Project	IEEE 802.16 Broadband Wireless Access Working Group http://ieee802.org/16 >		
Title	Efficient Signaling to Support Partitioning/Grouping for H-FDD Operation		
Date Submitted	2008-01-14		
Source(s)		E-mail:	
	Pallav Sudarshan	Pallav.Sudarshan@motorola.com	
	Jeff Zhuang	Jeff.Zhuang@motorola.com	
	Mark Cudak	Mark.Cudak@motorola.com	
	Motorola, Inc.	http://standards.ieee.org/faqs/affiliationFAQ.html	
Re:	IEEE 802.16 Working Group Letter Ballot Recirc #26a		
Abstract	Clarifications and signaling mechanisms are provided for efficient operation of H-FDD in 802.16e.		
Purpose	Accept the proposed specification changes on IEEE P802.16Rev2/D2.		
Notice	This document does not represent the agreed views of the IEEE 802.16 Working Group or any of its subgroups. It represents only the views of the participants listed in the "Source(s)" field above. It is offered as a basis for discussion. It is not binding on the contributor(s), who reserve(s) the right to add, amend or withdraw material contained herein.

Efficient Signaling to Support Partitioning/Grouping for H-FDD Operation

I: Modification to the legend of existing Figure 59 (copied below):

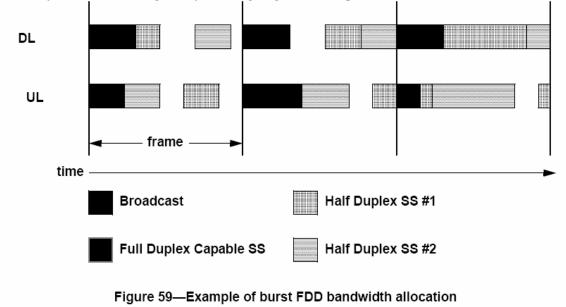
Fig 59 should denote the different temporal regions more generically as "Half Duplex Partition #1" and "Half Duplex Partition #2", instead of "Half Duplex SS #1" and "Half Duplex SS #2".
